SEIKO EPSON CORPORATION  
 Sales & Marketing Division.  
 MD Sales & Marketing Department.  
 MICRODEVICES Operations Division.  
 MD Production Control & Procurement Dept.

## 2016・2520 size TCXO tape packing specifications change notice

#### (2) Change point - Change of tape packing reel

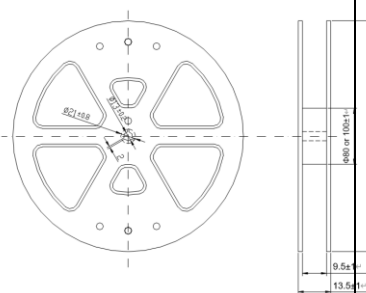
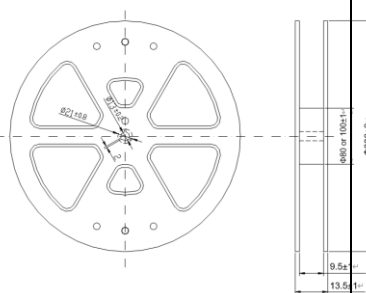
Currently, there is only one type of  $\phi 330$ mm reel, we will add a small diameter  $\phi 180$ mm reel according to the number of packages.

Item	Current	New	
Packing quantity	All types of packing quantity	Standard packing quantity 2016sizeTCXO : 12,000pcs 2520sizeTCXO : 10,000pcs (over 3,000pcs)	Packing quantity 3,000pcs or less
Reel size	diameter: $\phi 330$ mm 	diameter: $\phi 330$ mm 	<Addition> diameter: $\phi 180$ mm

**Current reel:  $\phi 330$  mm diameter**

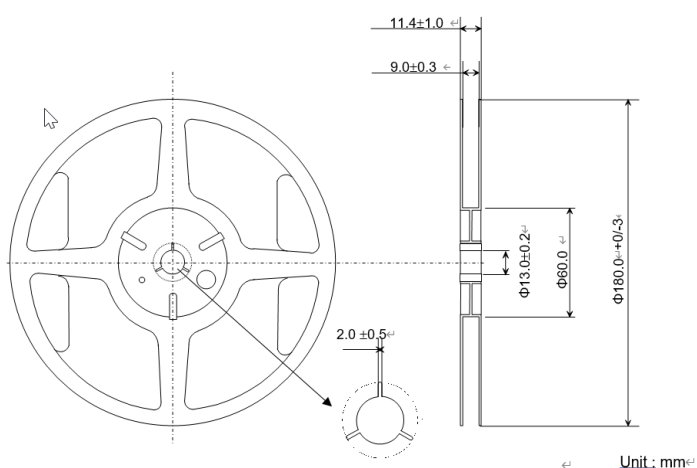
Material of the Reel リール材質: PS (Black / Conductive 黒/導電性) <sup>①</sup>

Form and Size of reel window shows are one of the example <sup>①</sup>  
リールの窓の形状は代表例を掲載。 <sup>①</sup>
